STATE OF MAINE  
DEPARTMENT OF TRANSPORTATION  
16 STATE HOUSE STATION  
AUGUSTA, MAINE 04333-0016

May 4, 2018  
Subject: Bicycle/Pedestrian Path  
State WIN: 018858.00  
Location: **Brewer**  
**Amendment No. 1**

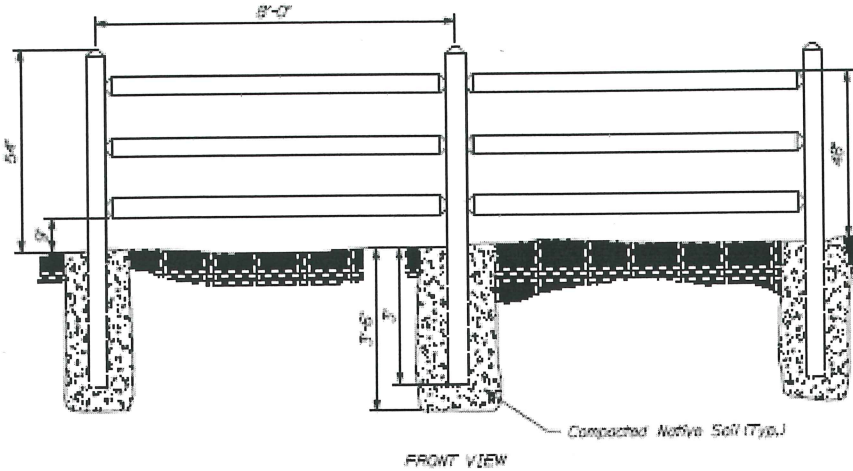
**Question:** Item #: 607.39 - Pedestrian Fence. Page 67 of the spec book calls out for the fence panel to be 'Ovation' style ornamental fence by Jerith Manufacturing Co, Inc. With framing to have 1 5/8 channels and 1" square pickets. This 'Ovation' style fence is only available with 1" X 1 1/2 rails and 3/4" square pickets. Please advise.

**Response:** The revised overall dimensions to the horizontal rails and the pickets are acceptable.
